Statement of Environmental Effects

Modification 4.55(1A) Application to Consent N0516/17

701-703 Barrenjoey Road, Avalon

Project No. 1715

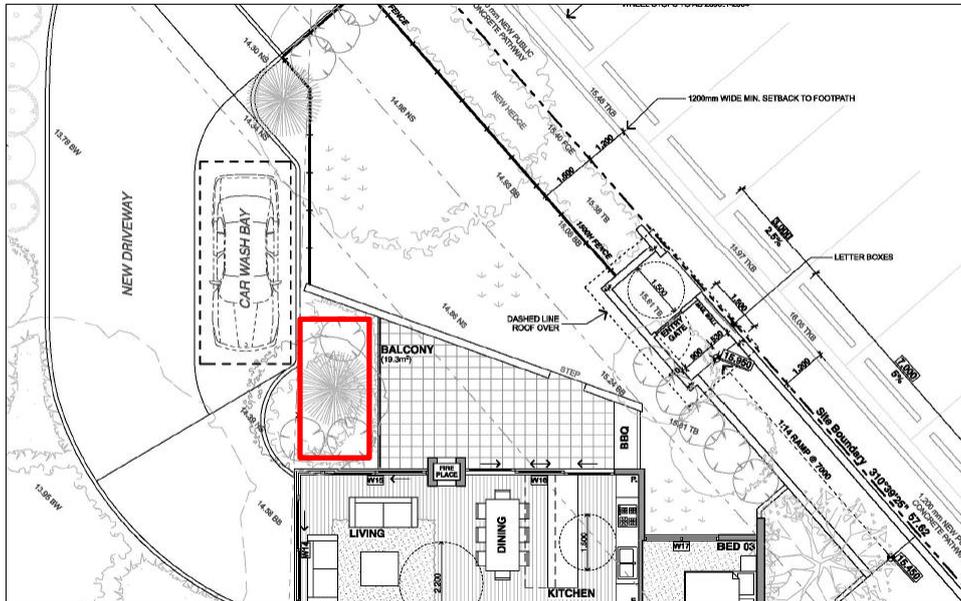
2. **Amend condition C4 by deletion of part b) of the condition**

The condition requires: *Deletion of the roof overhang on the south-eastern side of the balconies adjoining the southern side of units 2 and 4.*

- c) The deletion of the roof overhang will detrimentally affect the architectural integrity of the façade design (see images above). The roof overhang is located behind the 6.5m building setback line and does not cause any adverse bulk and scale, rather it provides quality to the design.

The reasons to delete the roof area are not justified in terms of improving the filtering potential of the landscape design, and therefore this part b) of condition C4 should be deleted

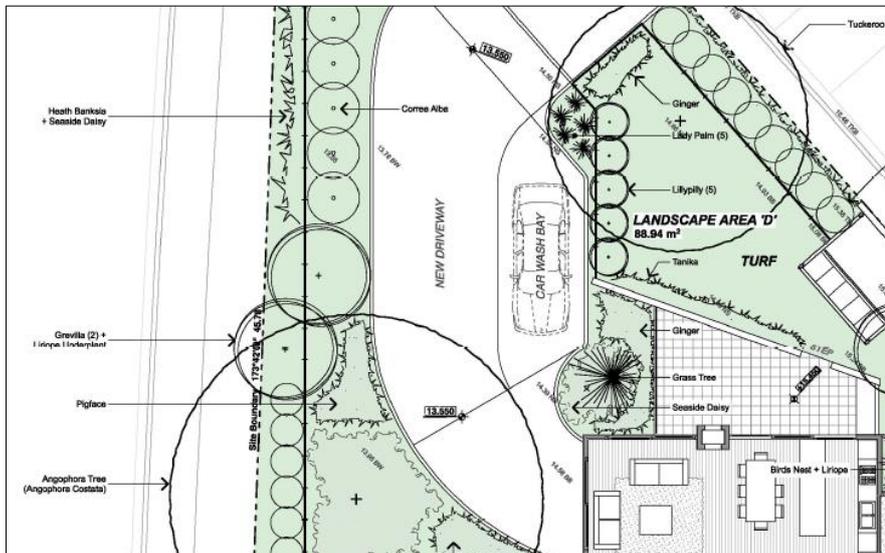
- a) The area of landscape under the roof overhang (as indicated in red) is approximately 4m x 2m in dimension. This area is NOT suitable for sustainable growth of canopy or screening trees, and its location is too close to the walls and balconies to sensibly grow landscape with a canopy of greater spread than 2m. The area is more suitable to shrubs and mid-sized plants that can soften the outlook from the dwelling towards the driveway and vice-versa. The deletion of the roof overhang will not improve the landscape outcome in this area.

- b) The landscape plan as approved, drawing A-09(A) provides for 2 large canopy trees in the setback area to screen and filter the visual impact of the development from the road intersection and public spaces to the south east (extract below). These are shown as Tuckeroo and Angophora trees. These trees are in a landscaped area with substantially greater soil area to support growth and are located more than 5m away from the building to allow 10m canopies to these trees without interference with the building. These trees are far more likely to reach maturity and provide the screening required.

The trees are also strategically located to visually screen build form, as shown in the perspective views below
